KIRKSVILLE REGIONAL AIRPORT KIRKSVILLE, MISSOURI MODOT PROJECT NO. 24-028A-1

ADDENDUM NO. 3 TO

CONTRACT DOCUMENTS, SPECIFICATIONS AND PLANS FOR IMPROVEMENTS TO THE KIRKSVILLE REGIONAL AIRPORT KIRKSVILLE, MISSOURI MODOT PROJECT NO. 24-028A-1

A GEOMETRY PLAN - TERMINAL

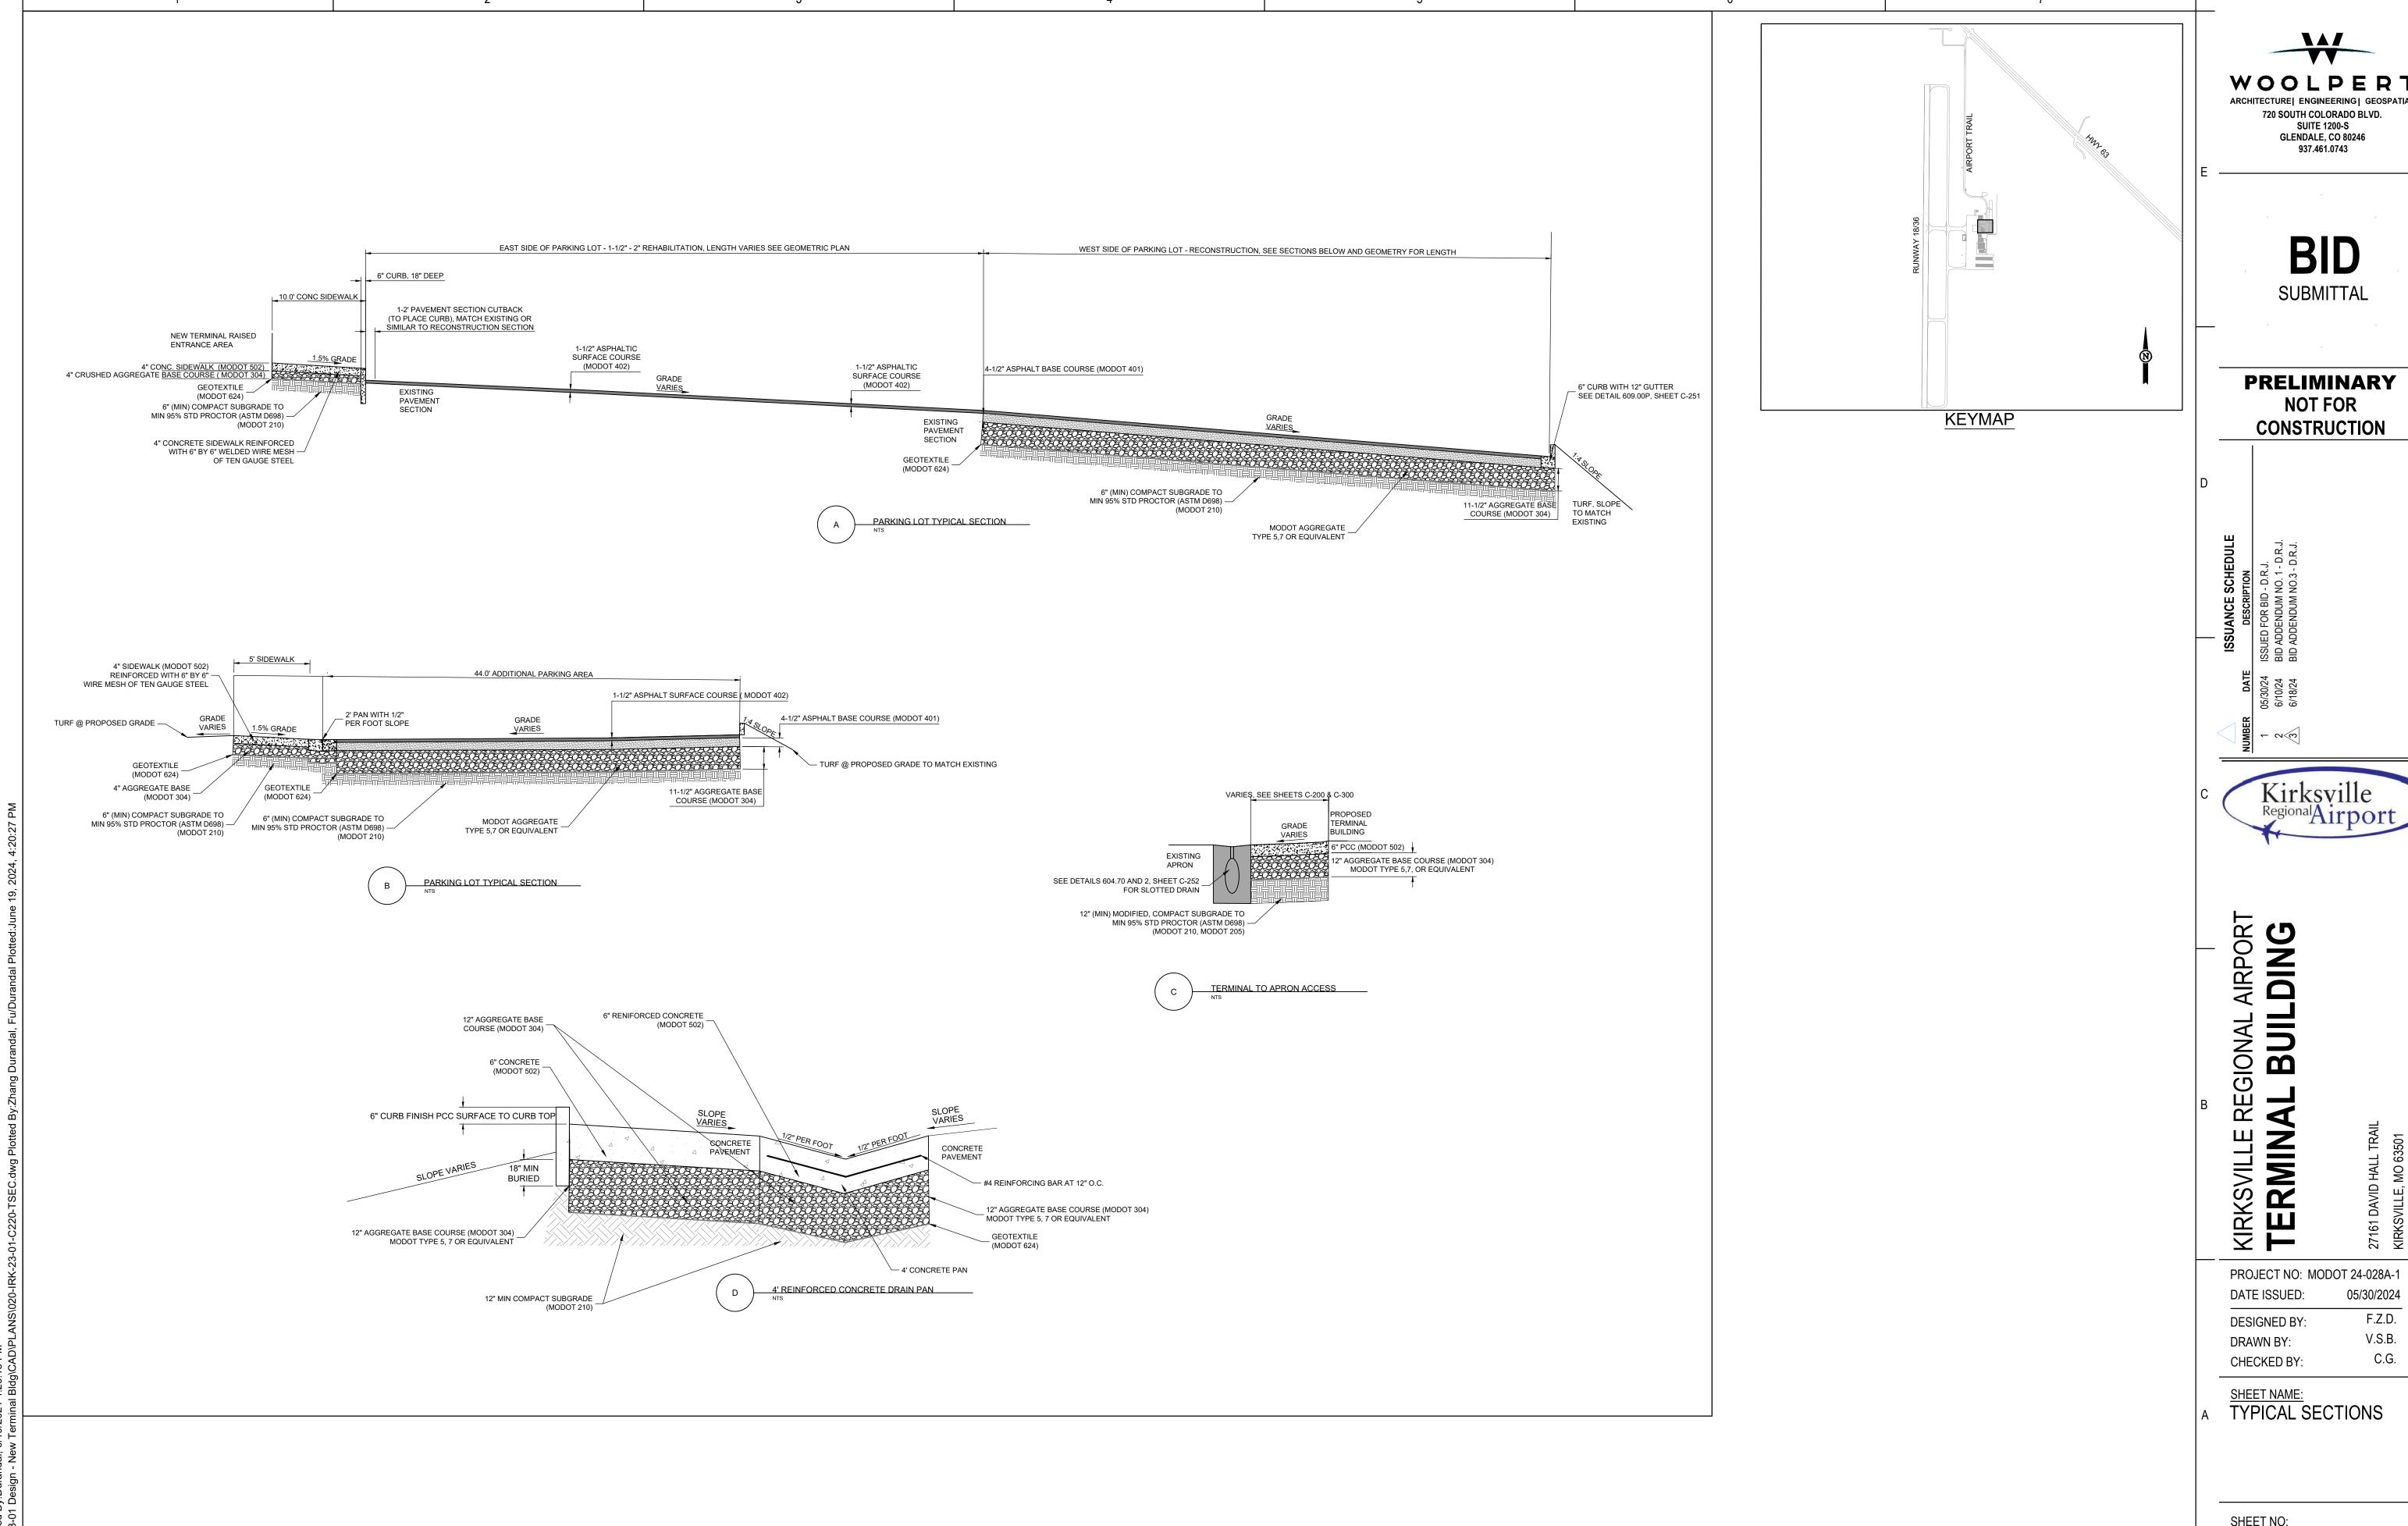
Revision: Modified ADA parking area to include ramps and curb. Modified east parking lot area to

include curb and gutter. **Justification:** For clarity.

A OVERALL GRADING PLAN

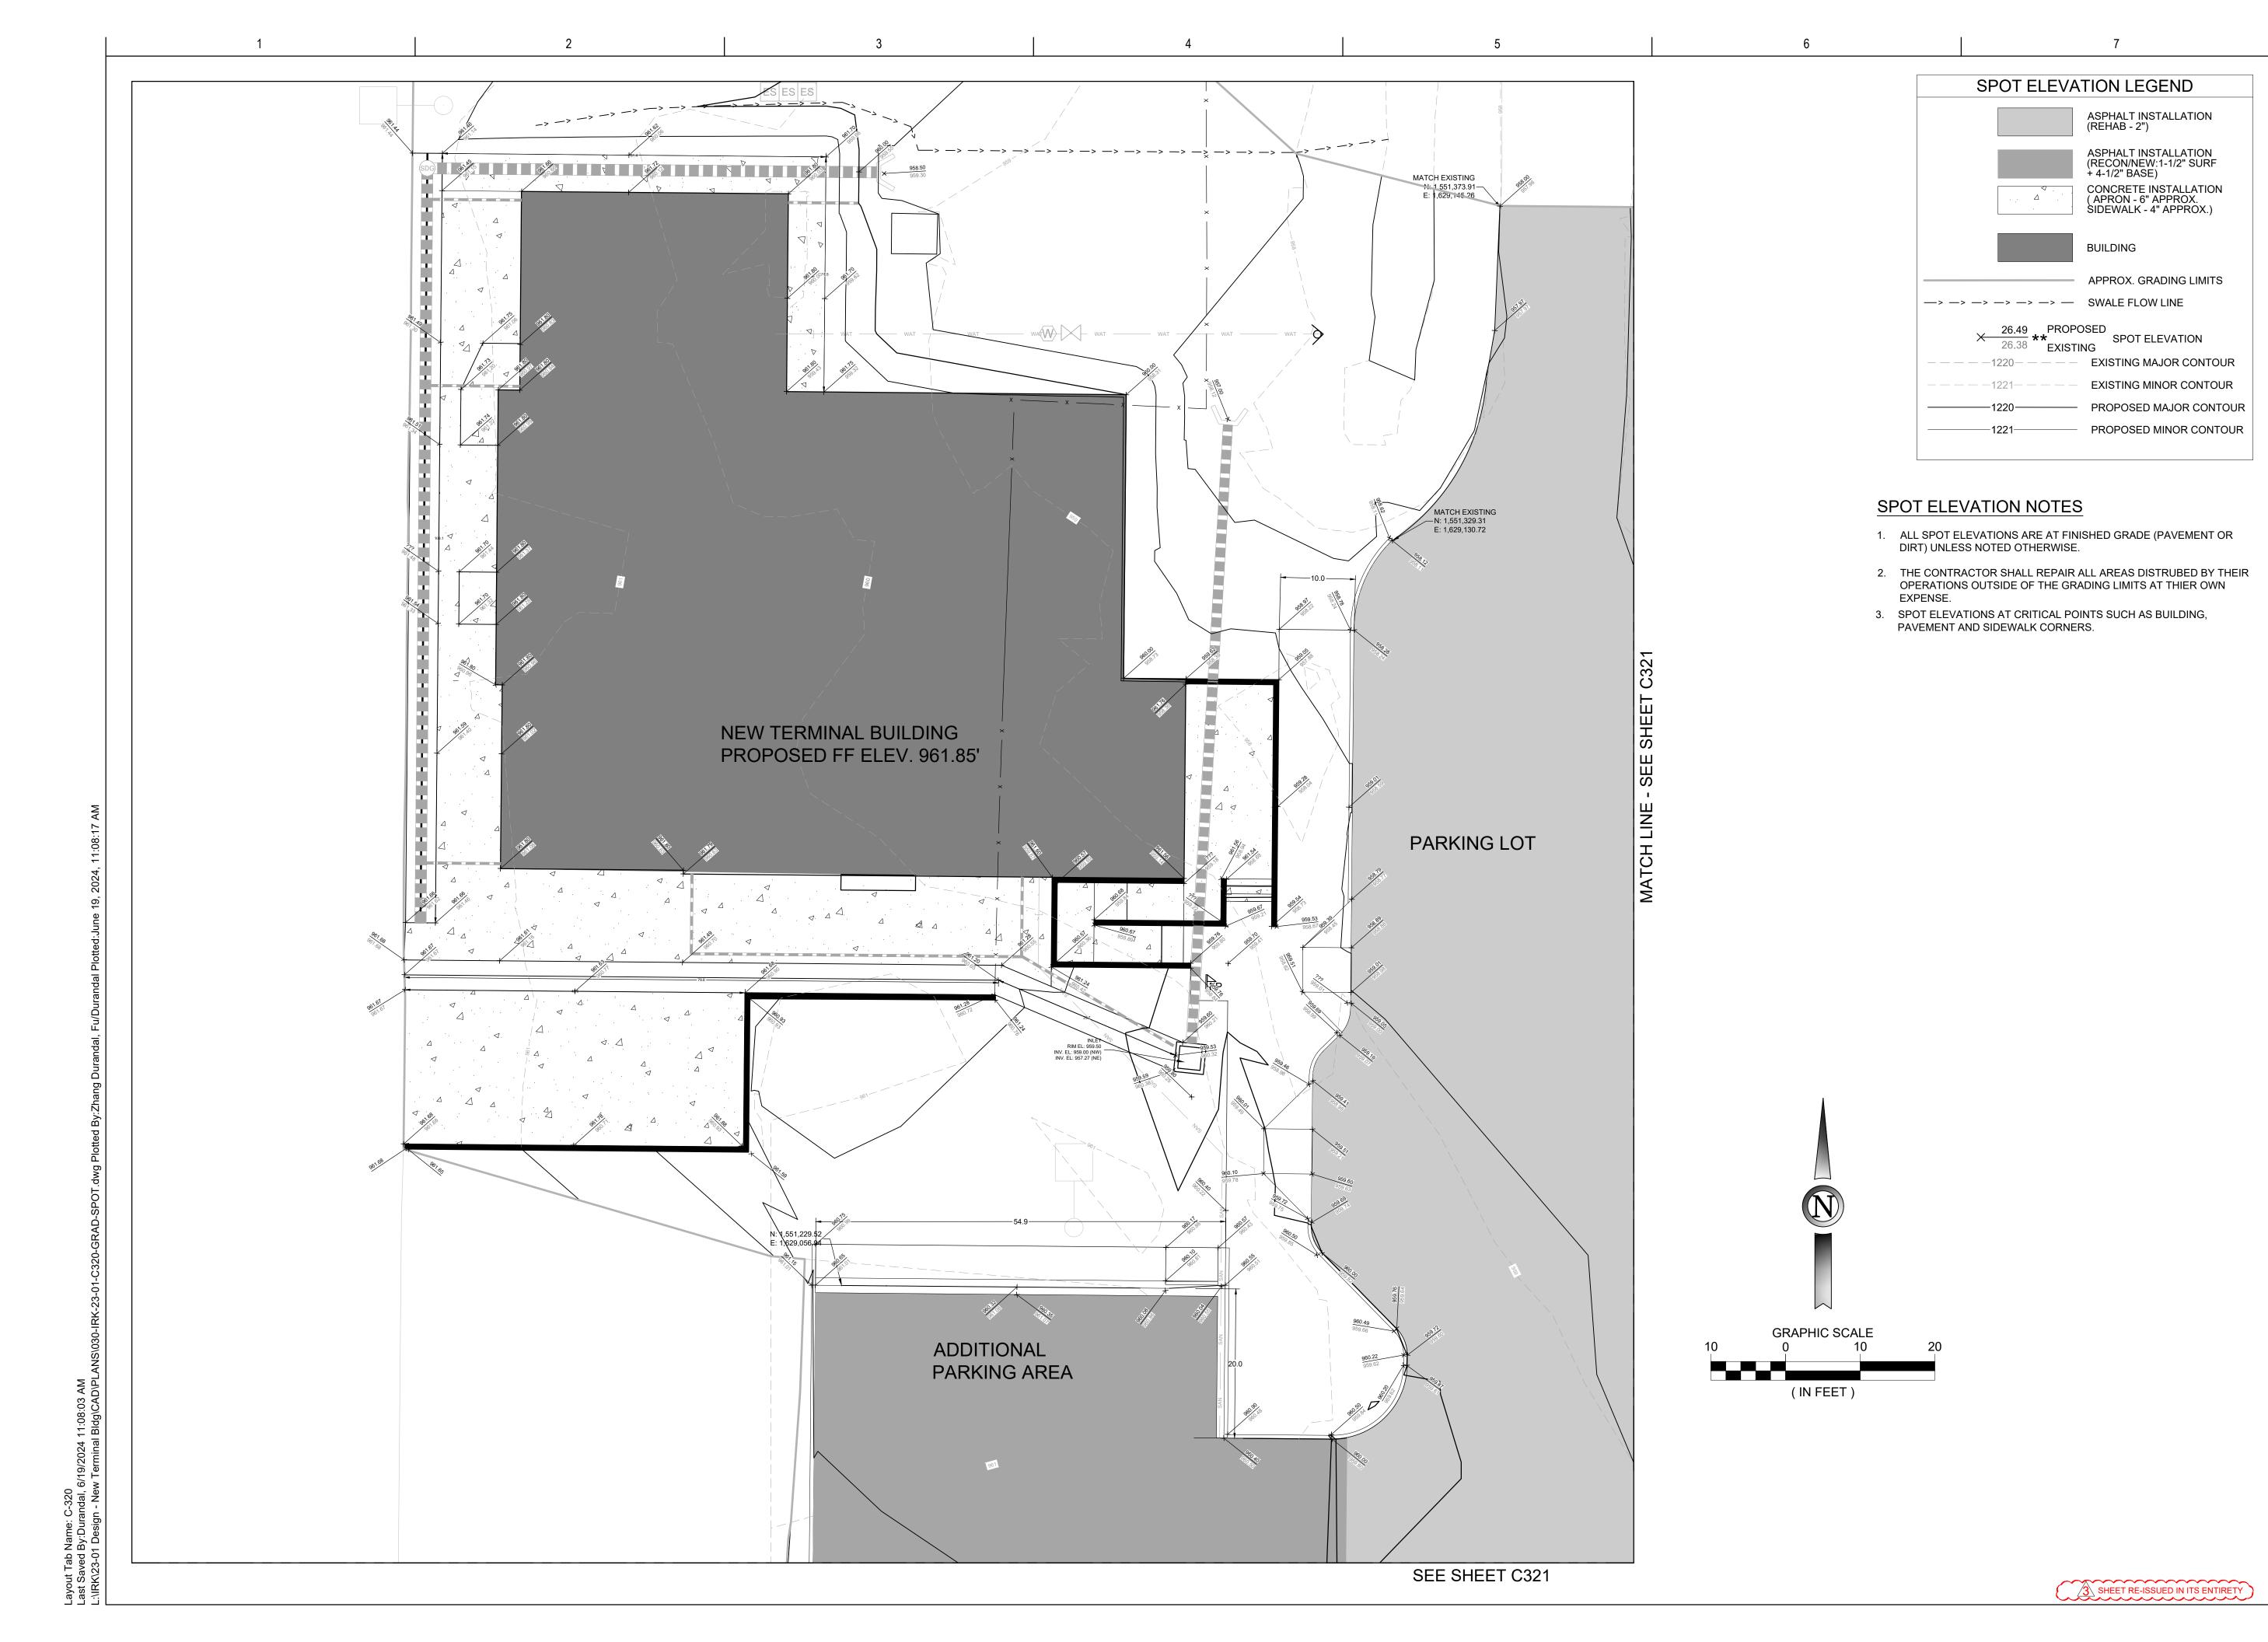
Revision: Re-issued for changed planimetrics in ADA parking area and east parking lot.

SHEET NAME:
GRADING SPOT
ELEVATION PLANS
NEW TERMINAL

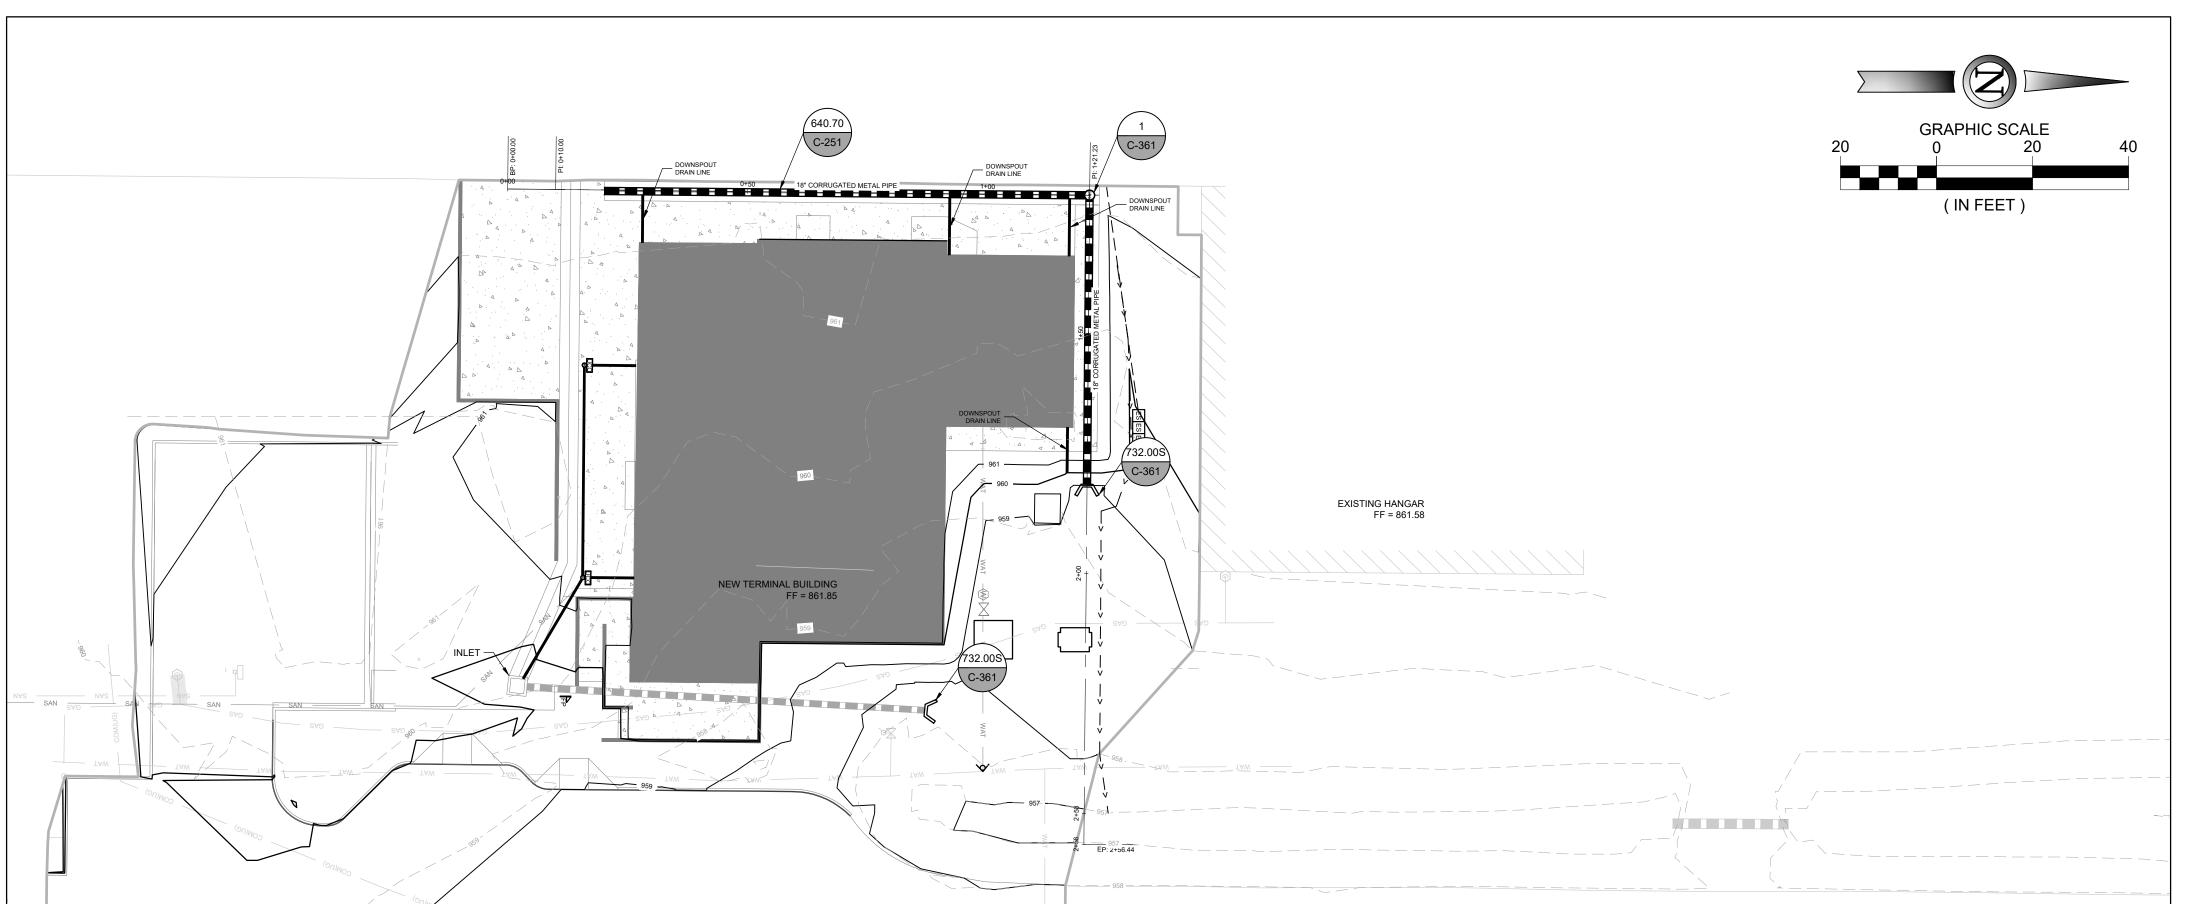
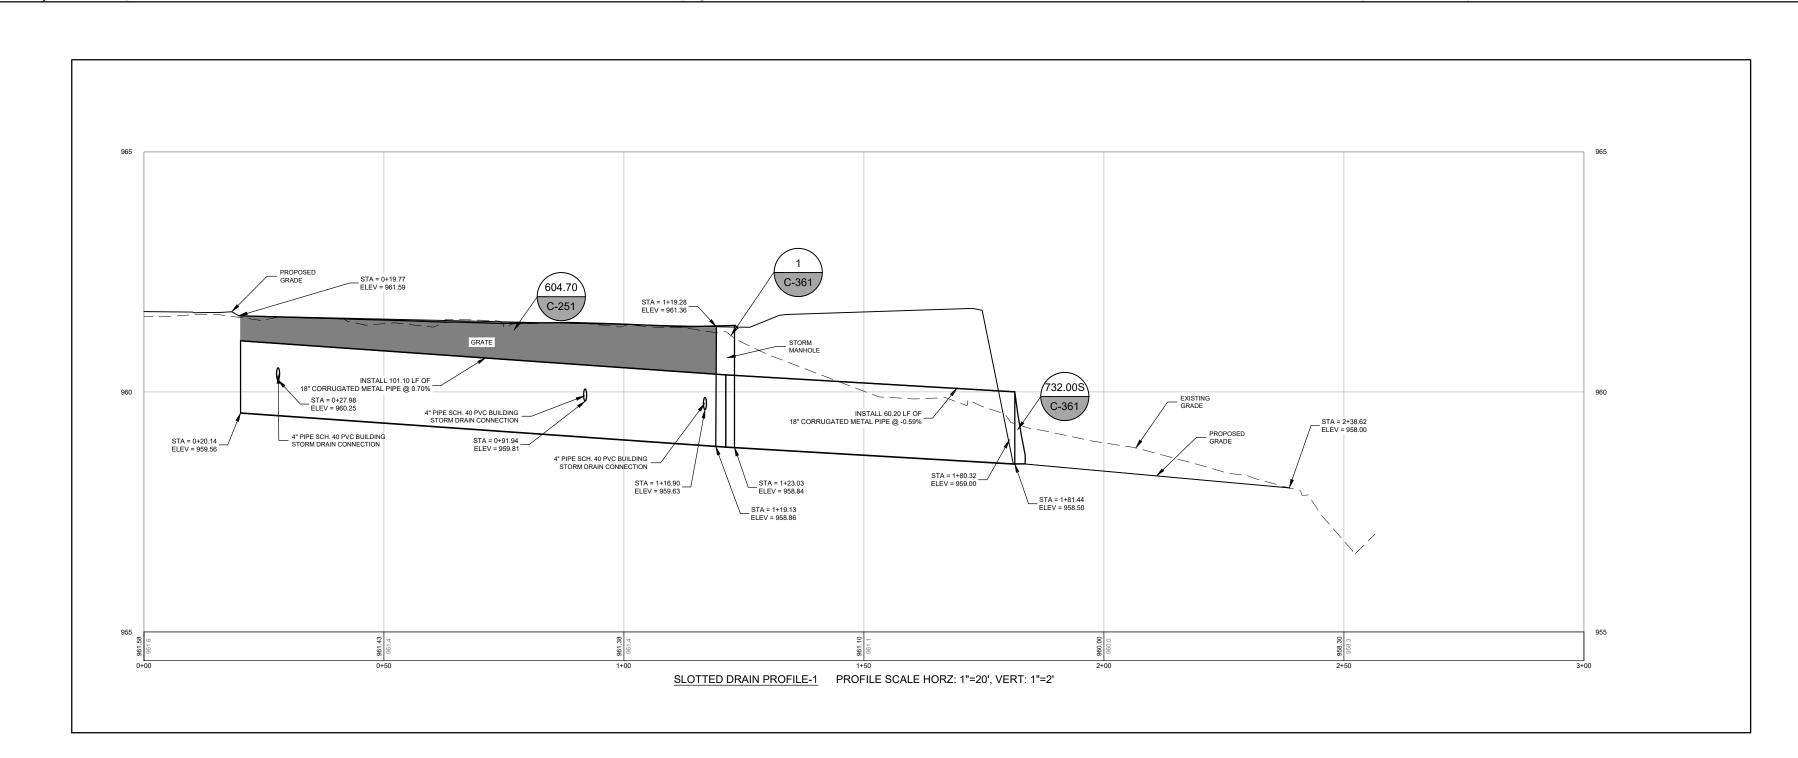
Revision: Joints shown on this plan have been removed. Layout modified to show ADA parking lot

area. Curb and gutter added **Justification:** For clarity.
